Body Repair Manual Welding & Sectioning Guideline Revisions

(Supersedes original publication, issued **April 2014**, to clarify procedures and add the latest information)

Rear Inner Panel Service Part Example

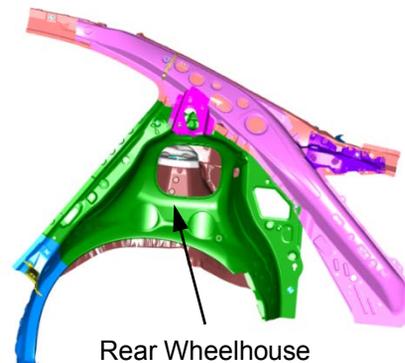
- Replacement of body service parts as supplied at factory seams is the preferred repair method, except when it may cause unnecessary or excessive intrusion into the body structure.
- In these cases, the service part may be disassembled at factory seams as required to replace only the damaged portion.
- For example, if only the vehicle's rear wheelhouse is damaged, that part may be removed from the rear inner panel service part assembly at the factory seams and installed on the vehicle.
- Note that there is **not** a BRM replacement procedure for rear inner panels because they are rarely installed as a complete unit.
- All basic welding & sectioning guidelines specified in the service information **must** be observed during partial panel replacement.

Sectioning Area Examples

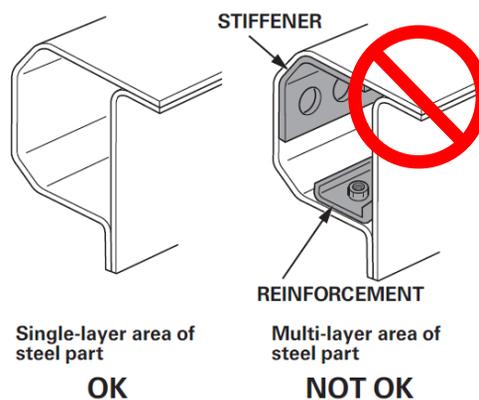
- Outer body and floor panels may be sectioned as necessary. Specific sectioning procedures are not provided in the body repair manual.
- Depending on the type of vehicle damage, steel parts with a tensile strength of 780 MPa or less may be sectioned **if all three of the following conditions are met:**

1. Sectioning must be done in a single-layer area of the part.
 2. Multi-layer internal steel reinforcements and stiffeners must not be cut.
 3. Do not section in load bearing areas, such as engine, transmission, or suspension mounting points.
